# Romo Fashion Today Ltd. (9373)

31.05.2014

# Identified Priority 1 Concerns

## 1<sup>st</sup> Priority 2 Concern

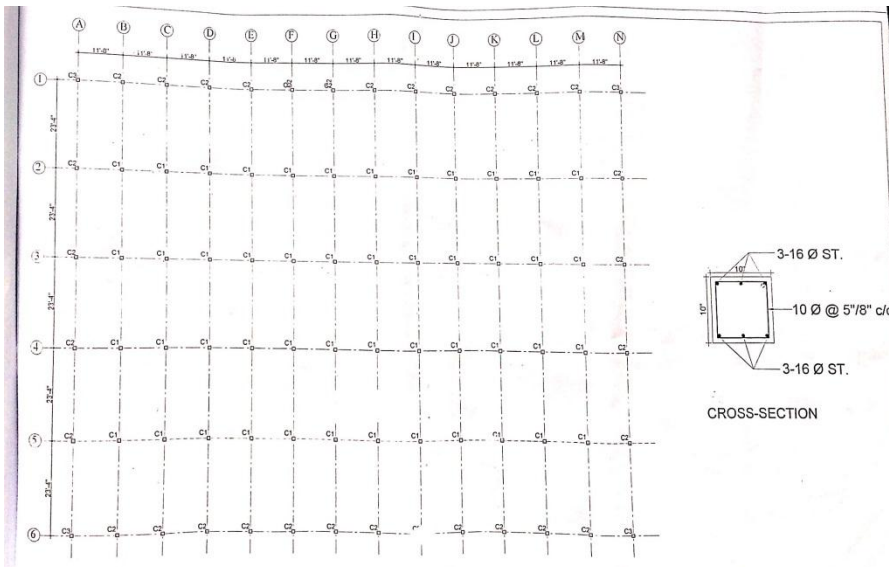
For the Office Building, there were no structure documents for the roof, the walls or the foundations.

For the Factory Building, the column schedule is incomplete; we noted some columns were not listed at all.

## 2<sup>nd</sup> Priority 3 Concern

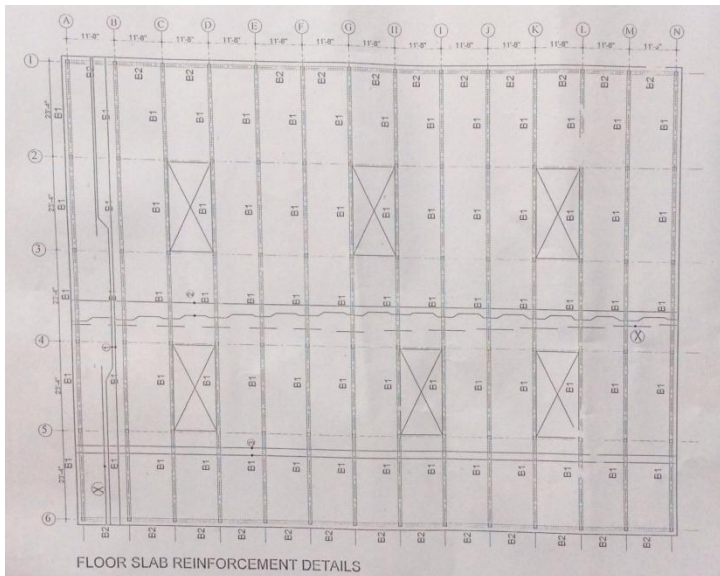
The Factory Building has reinforcement steel bars extended above the roof slab. This will allow rainwater to seep into the concrete slab and cause long-term soaking of the slab. The reinforcement should be removed and new waterproofing should be applied to the entire roof..

OFFICE BUILDING

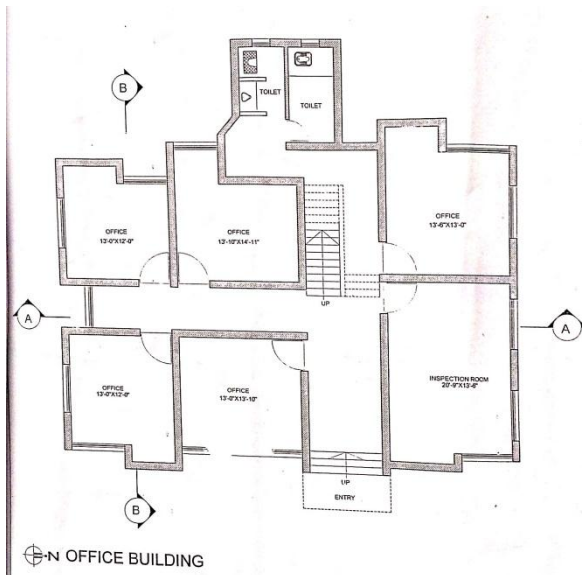
In the Office Building, the building structure is composed of concrete slab at the roof. This slab is supported by masonry walls of 250mm thick. These walls are used also as architectural partitions and provide the overall stability.
